VKPA/C 81401/81410

Technical Bulletin - February 2010

SKF Water pump seal evolution

VKPC 81410

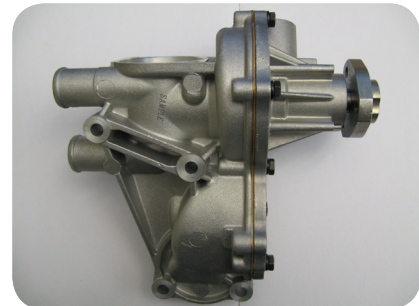
To avoid fitting issues and to limit water pump leakage risks , SKF has replaced the VKPA-C 81401 paper seal by the VKPA-C 81410 design metal seal:

- VKPA 81401 is replaced by VKPA 81410
- VKPC 81401 is replaced by VKPC 81410
